TO: Robert Palmer, Strategic Land Solutions, Inc.
FROM: Cynthia Thye, Planner I
DATE: April 3, 2026
SUBJECT: SP24-012: Parker Central Area F5 L2 B1 - McDonalds– Site Plan Amendment Review Comments 04

Description: Parker Central Area F5 L2 B1 - McDonalds

SHEET NO: **LS1.1**

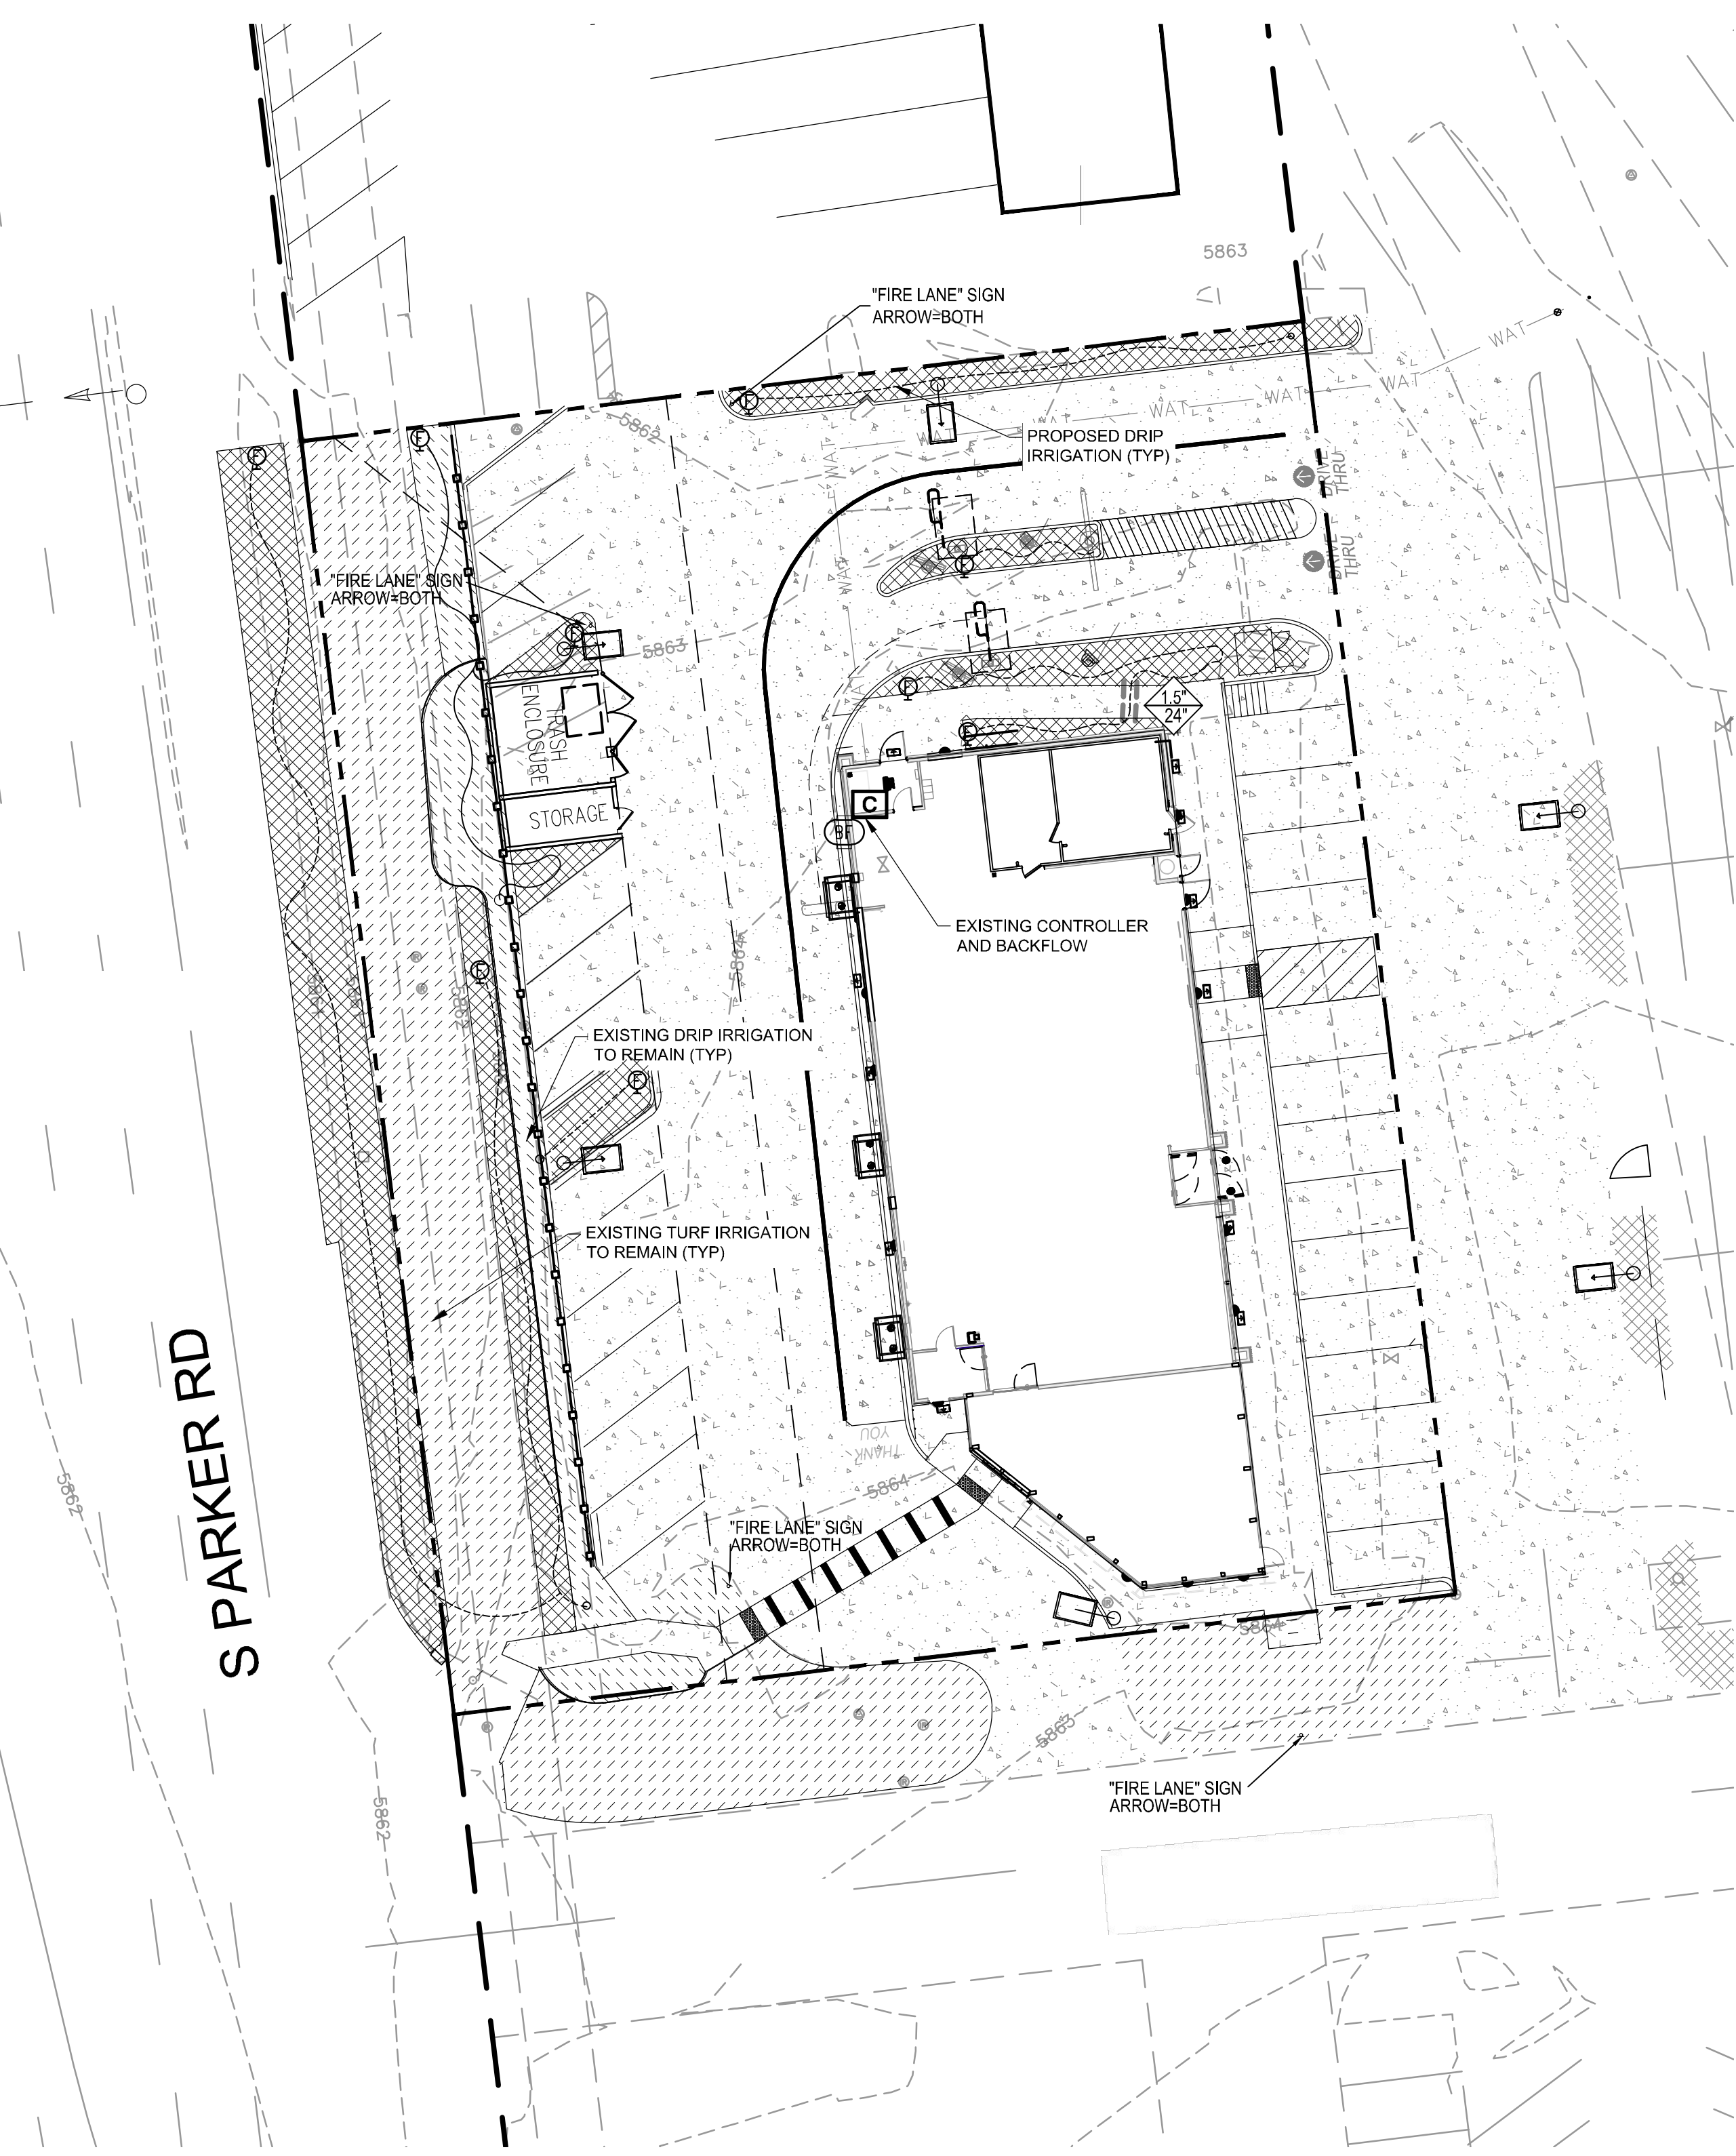
1. Regarding Tree Mitigation Chart, many applicants choose to replace. If relocate, need an arborist to value this tree. See requirements for tree location LDO 13.08.090(l).(6).e.

See requirements for tree location LDO 13.08.090(l).(6).e. Many applicants choose to replace. If relocate, need arborist to value this tree.

ISSUE	DATE
PROJECT #:	0826
DRAWN BY:	CS
CHECK BY:	
SHEET TITLE:	EXTERIOR ELEVATIONS
DRAWING NO:	A3.01

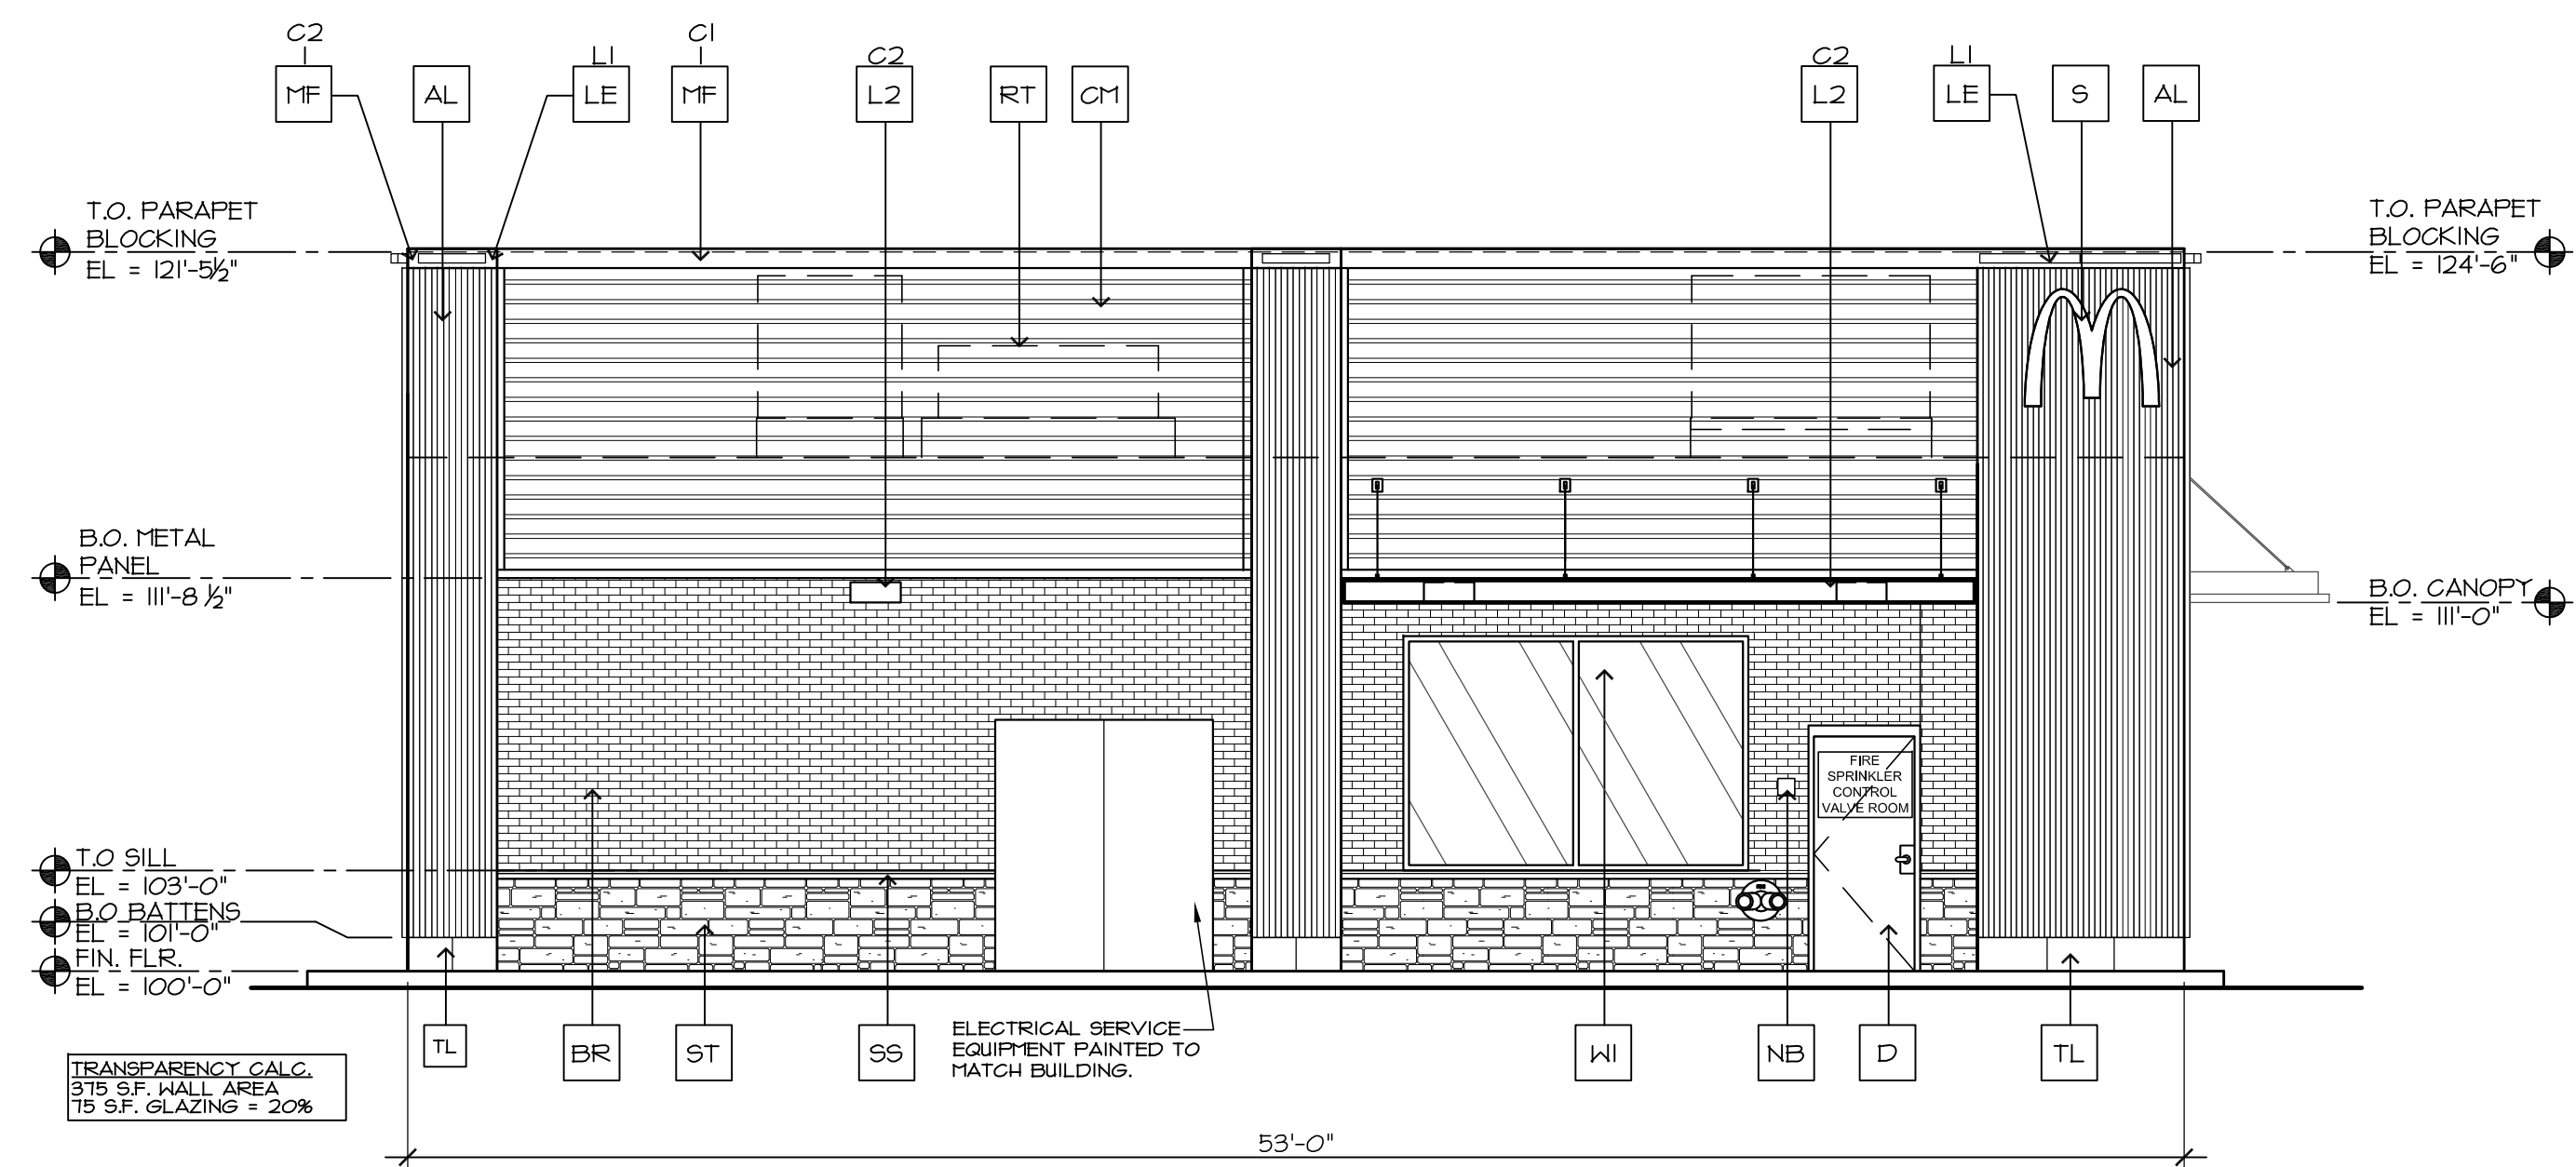
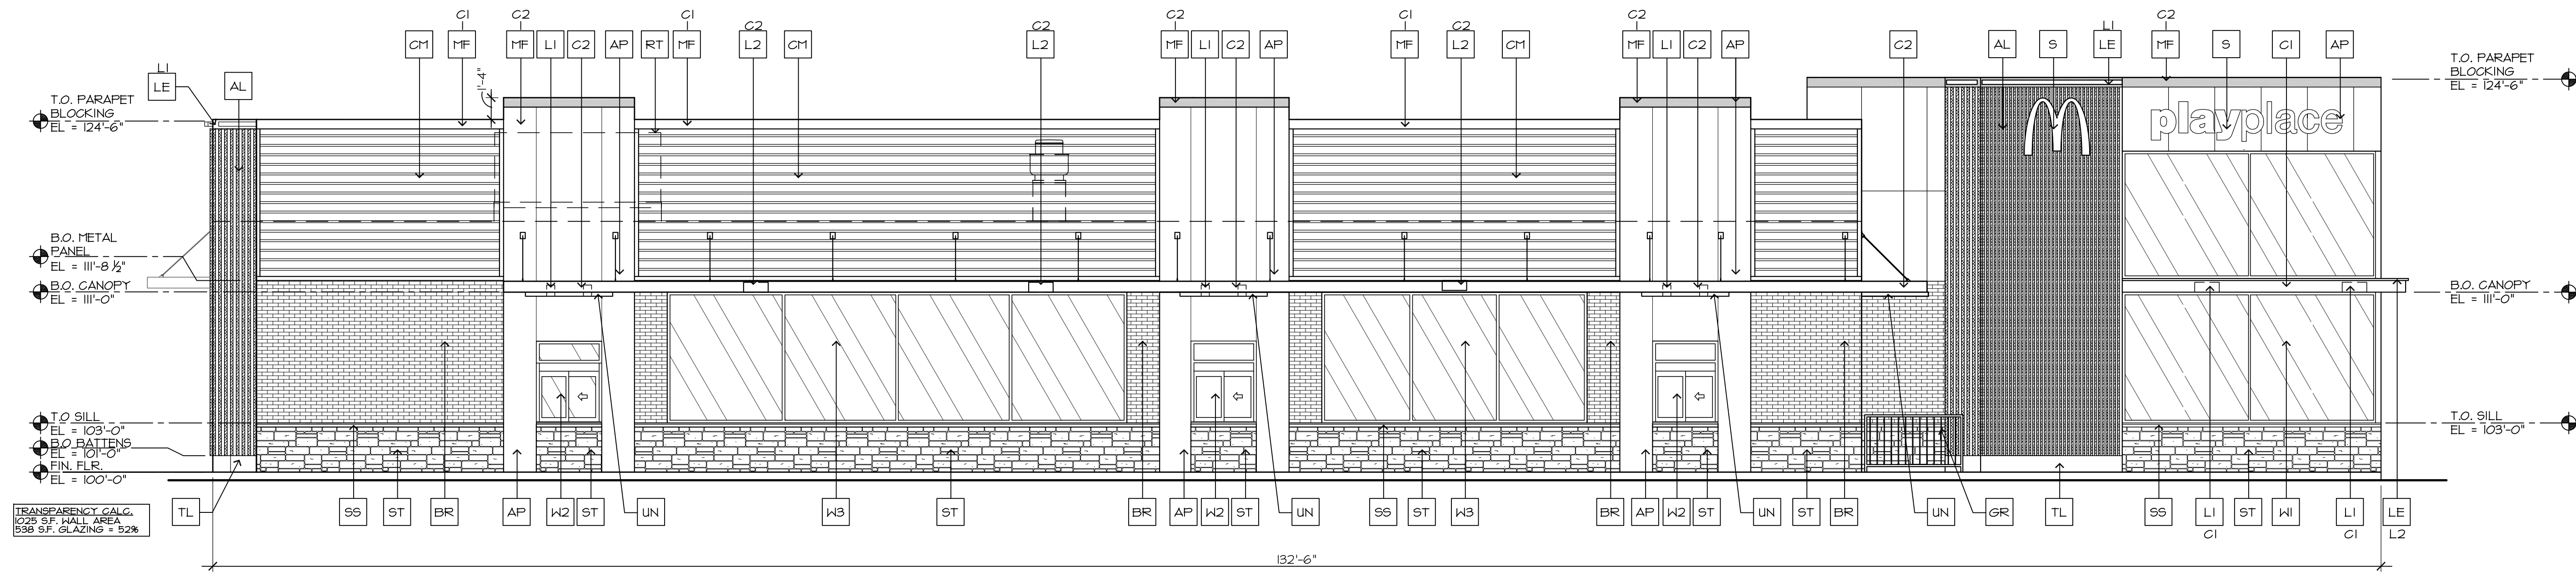
- 1. Revise – “storefront” is not a material. Change this to the material - i.e. type of glass.**

- 3. Second request - Show wall-mounted electrical equipment, add note that it will be painted to match adjacent wall.**

Second request - Show guardrails on elevations.

Second request - Show wall-mounted electrical equipment, add note that it will be painted to match adjacent wall.

Revise - storefront is not a material. Change this to the material - i.e. type of glass.
